BOARD OF WATER SUPPLY

Subject: Board of Water Supply (BWS) Comments to the Work Plan / Scope of Work, Investigation and Remediation of Releases and Groundwater Protection and Evaluation, Red Hill Bulk Fuel Storage Facility

The BWS and its consultants have reviewed the document titled "Work Plan / Scope of Work, Investigation and Remediation of Releases and Groundwater Protection and Evaluation, Red Hill Bulk Fuel Storage Facility" (WP), dated 4 May 2016, under the Administrative Order on Consent (AOC) Statement of Work (SOW) Sections 6 and 7. Our review of the WP also includes information and statements from the Tuesday 10 May 2016 meeting concerning the AOC scopes of work for AOC SOW Sections 6 and 7. The BWS provides the following comments and recommendations to the WP with the goal of ensuring that all work conducted under the final document will produce defensible scientific and engineering results needed to continue to protect our drinking water supplies from past and future fuel releases from the Red Hill Bulk Fuel Storage Facility (RHBFSF).

Figure 1. Hydrogeologic Scales for Basalt Vadose Zones

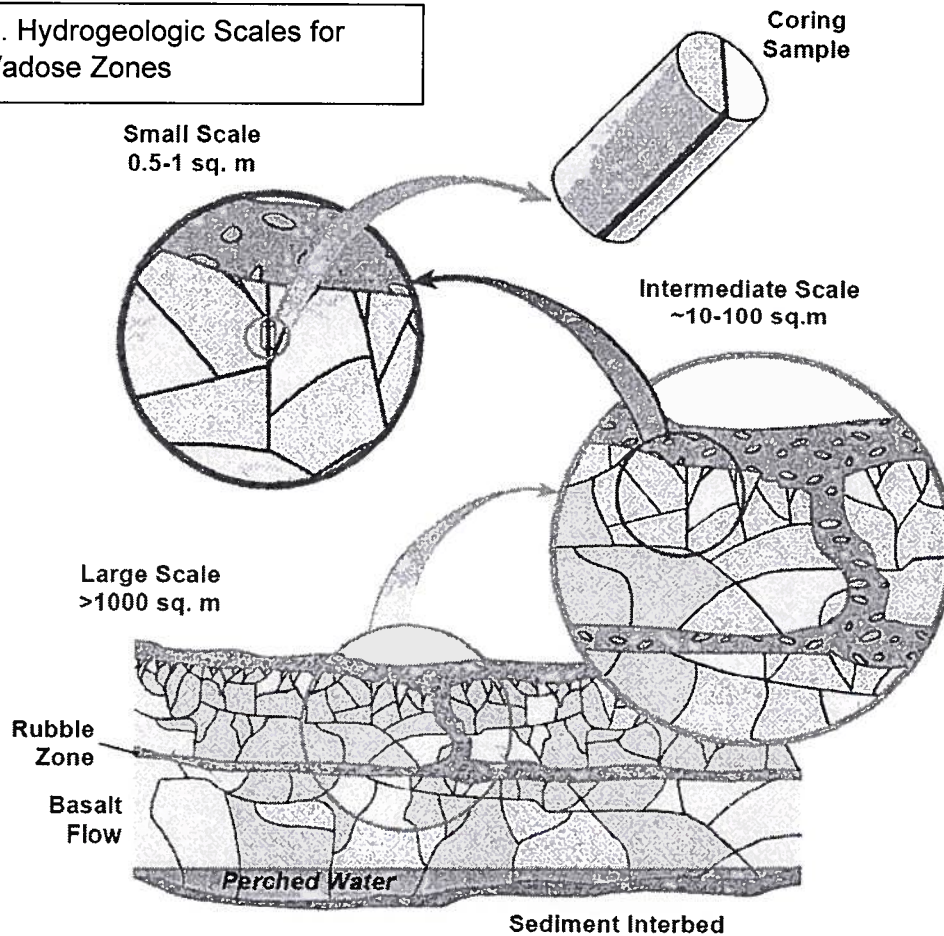
23. Section 3.7.4: Lines 10 through 14 are misleading and should be removed. The statements about low vertical permeability in the basalts presented here and in Sections 3.6.2.3 and 3.7.3 may well be true at small scales on the order of 1 meter², but such statements are readily contradicted by the fact that recharge occurs at rates between 10 and 25 inches per year in the Red Hill vicinity (see Oki, 2005 and Giambelluca 1983 for example). The authors appear to be solely focused on the micro-scale, whereas recharge and contaminant migration occur at the intermediate to large scales (Figure 1 below, which is adapted from Figure 3 in Fabysenko et al., 2000). If the massive components of a'a flows are so impermeable, how can

recharge occur at such a large rate over such a large area? If recharge is negligible

at Red Hill, why has the Navy invested so much into the system of collection trenches, sumps, and treatment units to handle infiltrating water? If the vertical permeability is so low as to impede vertical flow, why aren't they preventing the fuel contamination from migrating through the vadose zone into the groundwater, causing rising concentrations in vapor below Tank 5 and at monitoring well RHMW02? Relatively rapid migration of infiltrating water through massive basalt flows for small, intermediate, and large scales has been well established elsewhere (Fabysenko et al., 2000; Fabysenko et al., 2001; Baker et al., 2004), and the authors are encouraged to study these reports. As neither water nor fuel appear to have any problem moving vertically through the basalt vadose zone, this text should be revised to account for the large mass flux of water migrating through extensive areas of the basalt vadose zone.
